Title: Thunderbolt 3 VSEC6 Common Region Applied to: USB4 Specification Version 2.0

Actual Change

(a). Figure 13-7. Structure of the Common Region

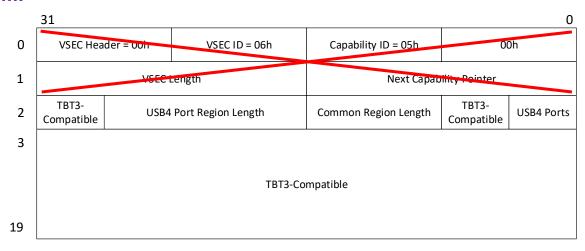
The Common Region description is updated not to include the VSEC6 header DWs. The Common Region is part of the NSEC6 in the Router CS of a USB4 Device that is a TBT3 compatible.					
ne VSEC6 in the Router CS of a USB4 Device that is a TBT3 compatible.					
Benefits as a result of the changes:					
accurate description of the eco system and the HW requirement for a USB4 device which is a TBT3 compatible.					
An assessment of the impact to the existing revision and systems that currently conform to					
he USB specification:					
Jone.					
an analysis of the hardware implications:					
Implement the VSEC6 in the Router CS.					
ilpiement the VSECo in the Router CS.					
an analysis of the software implications:					
an analysis of the compliance testing implications:					
Jone.

Remove the first two DWs from the Common Region description as it is already described in the previous section.
